Further Information Response (P. Ref. 24/60545)

**Proposed Sand & Gravel Pit Extension, Mounthall &
Cummer townlands, Camross, Co. Laois**

Breedon Materials Limited (trading as Breedon Ireland)

Plate 3-1: Extract from EIAR Figure 4-2 showing receptor locations

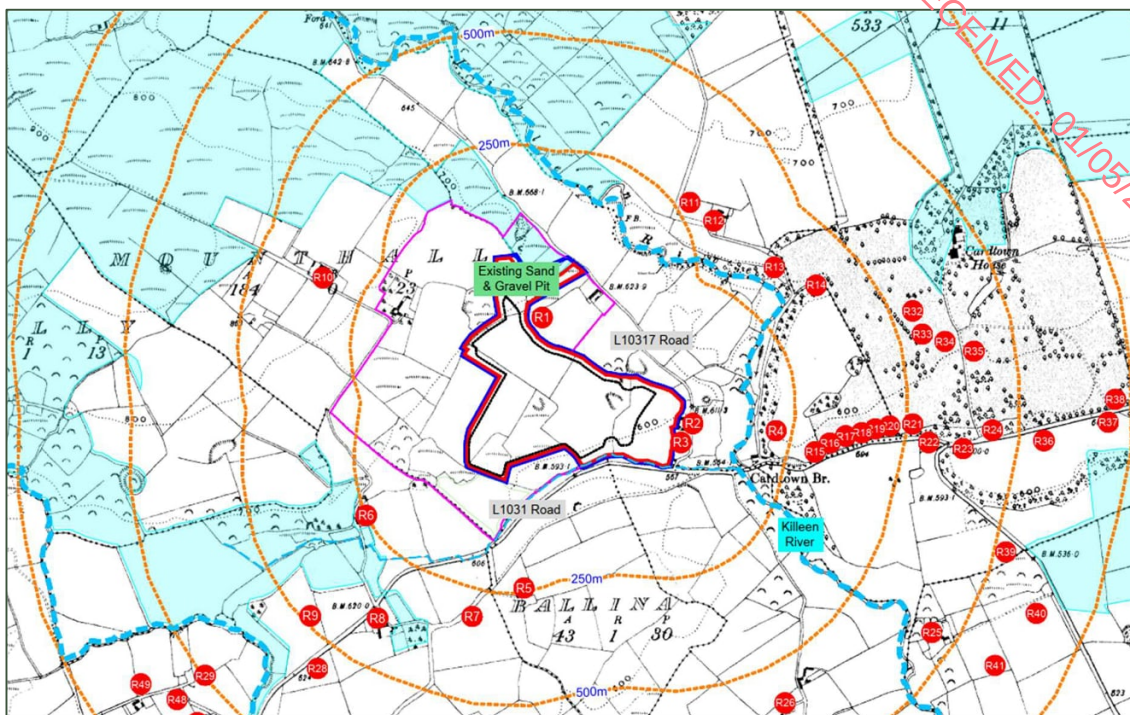
The Planning Authority notes that Chapter 4 refers that there are 21 no. sensitive residential receptors within 500m of the application site.

A review of all EIAR chapters, the non-technical summary (NTS), planning report and Natura Impact Statement (NIS) was carried out to check and confirm the correct number of residences within 500m and 1km of the site boundary.

Table 3-1 below summarises the receptors located within 1km of the site and their distances from the red line application boundary. **Plate 3-1** (extract from EIAR Figure 4-2) below shows the receptor (residence) locations plotted at a scale of 1:10,000. Owing to the scale of the mapping and the annotation of the receptor number being a size that is legible to the reader, R21 is showing overlaying the 500m off-set distance boundary, even though it lies just outside the 500m radius at a distance of 505m. It is for this reason it is included in the count of residences within 500m.

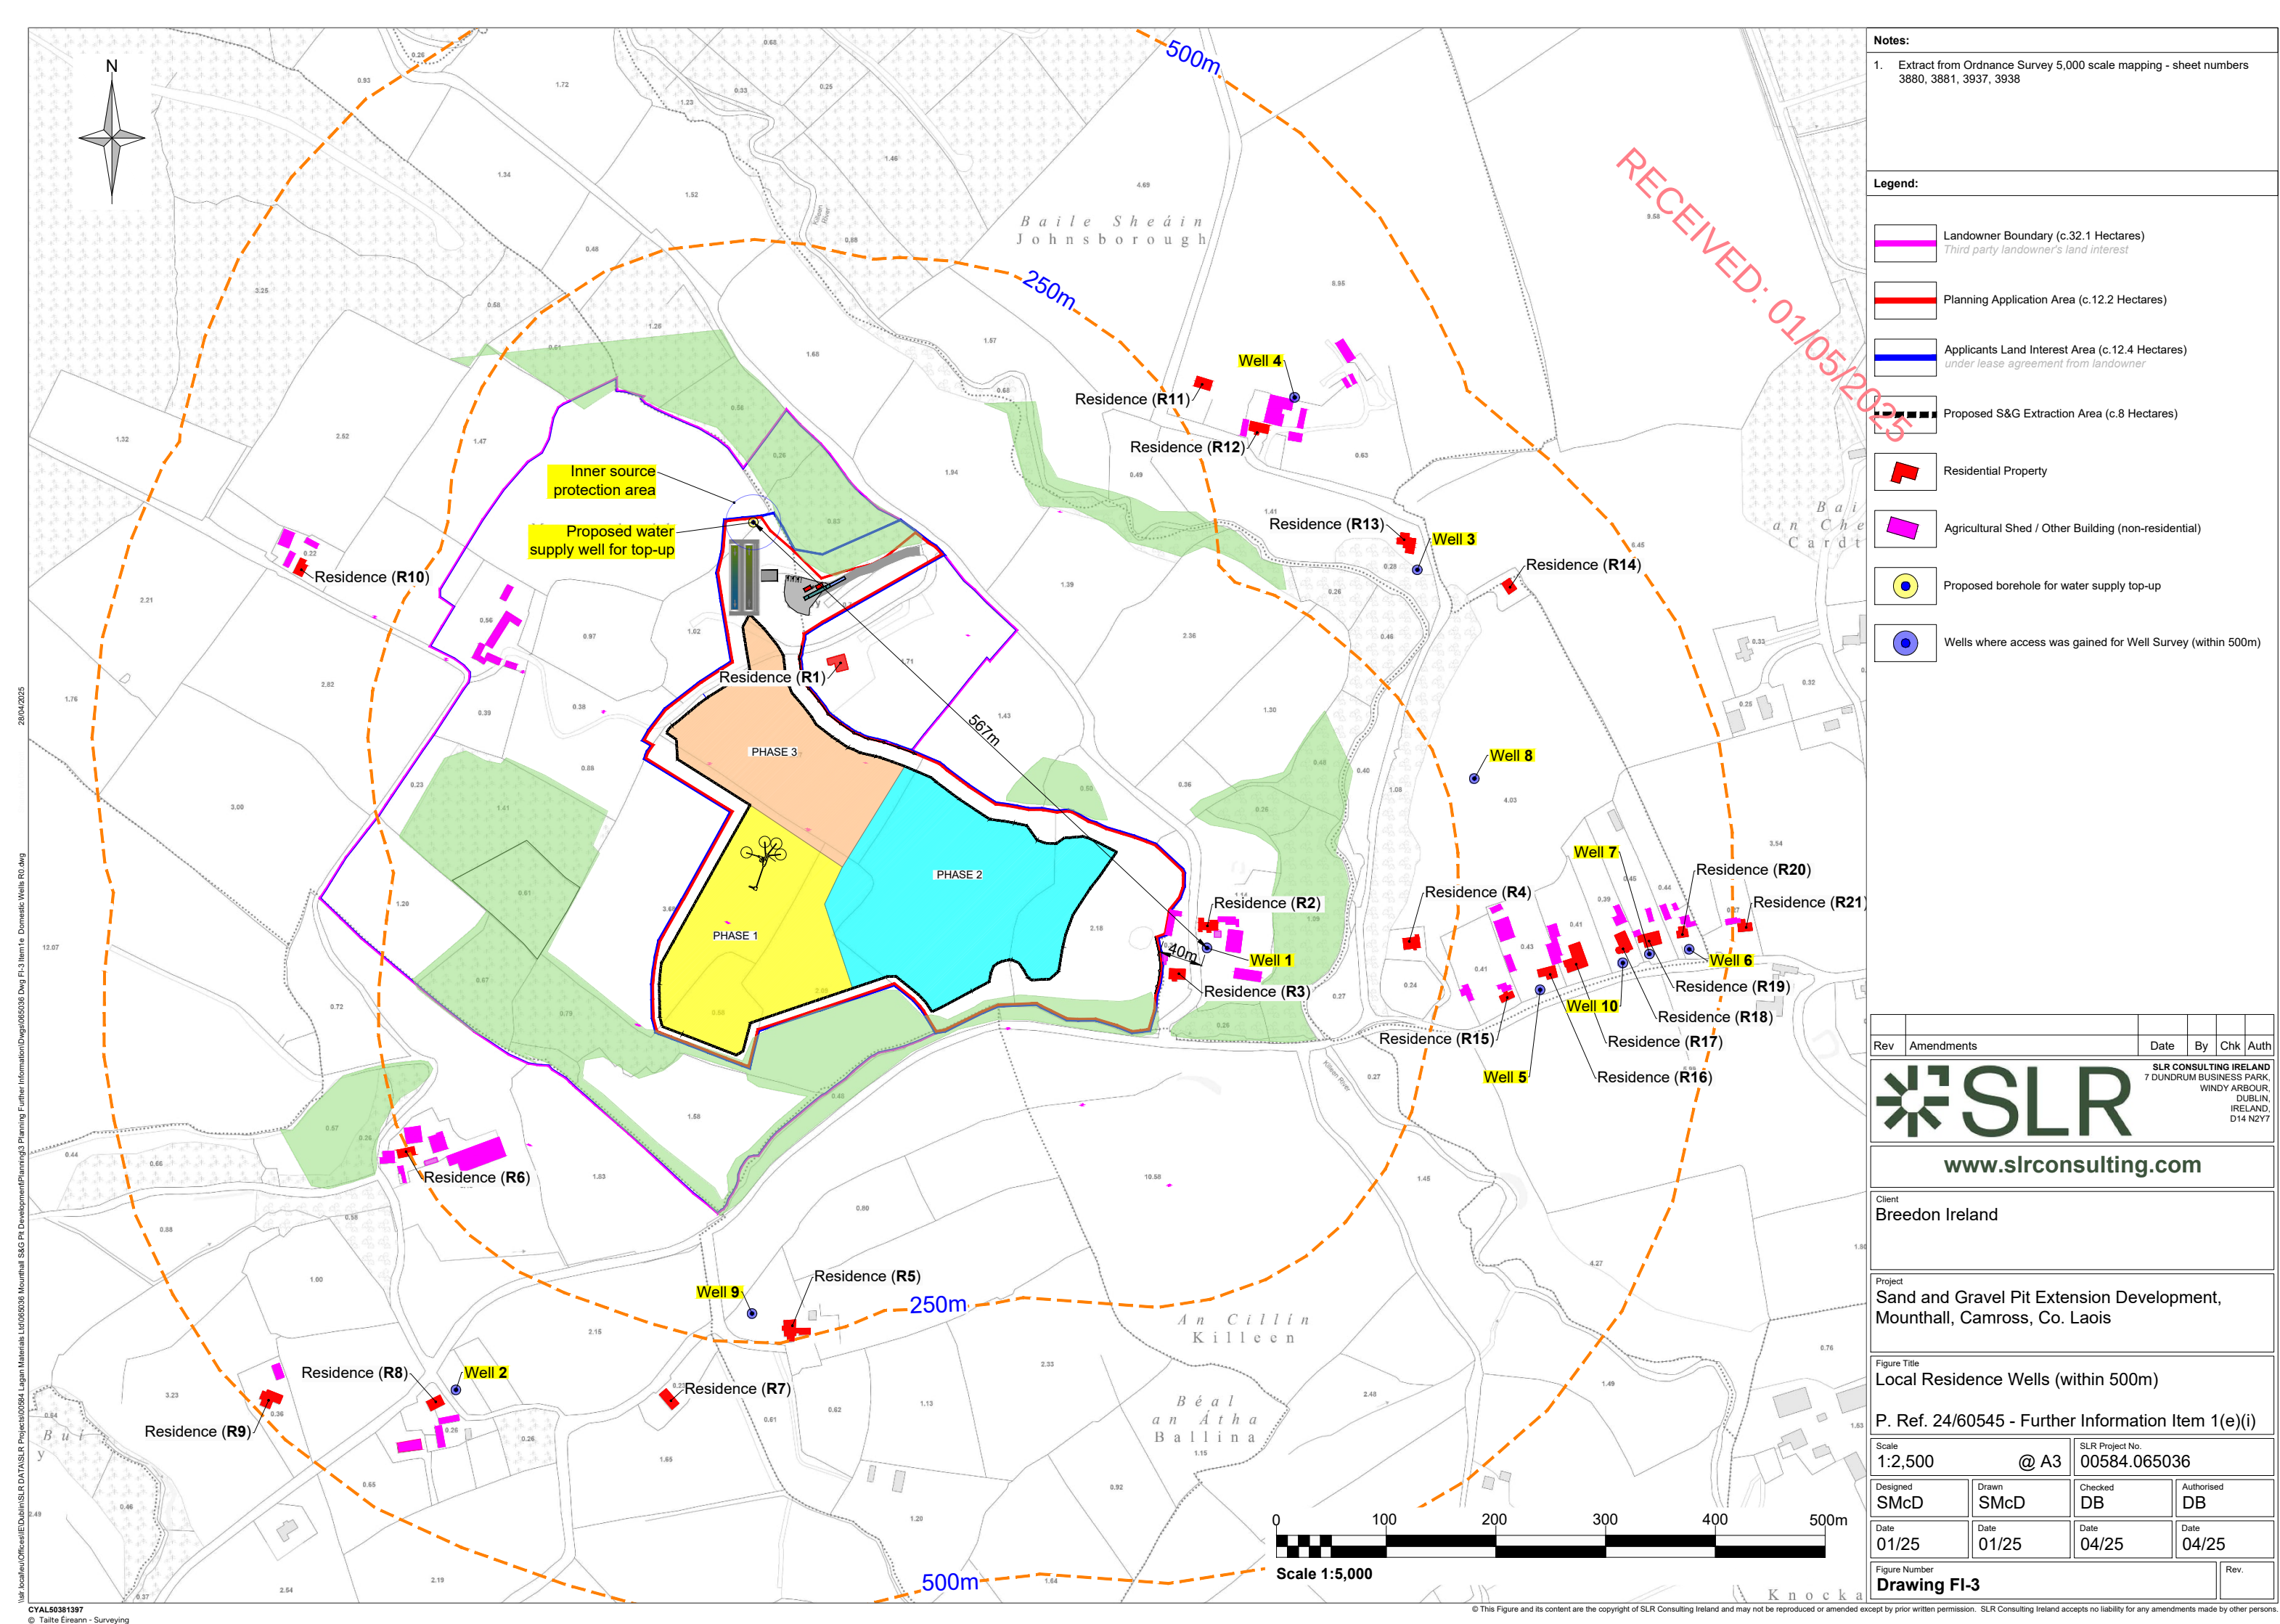
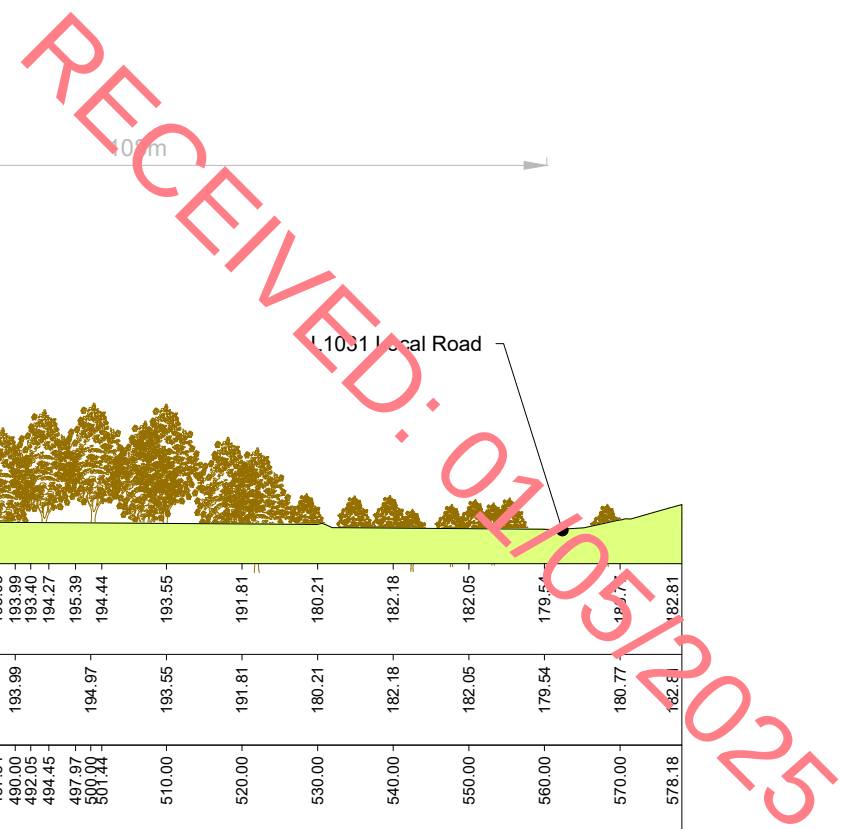
However, the Department of Housing, Local Government and Heritage (DHLGH) response states that upon a site inspection further badger setts were identified on the site boundary, and some are in frequent use. This requires further attention by the applicant. See below the full response from the DHLGH.

The woodland / scrub habitat in which the five outlier setts were located was searched as thoroughly as possible; four of which are actively used by badgers. None of these setts are considered main setts and furthermore, a main sett could not be found on the site. **Drawing FI-2b** shows the accessible route that was possible through this habitat.
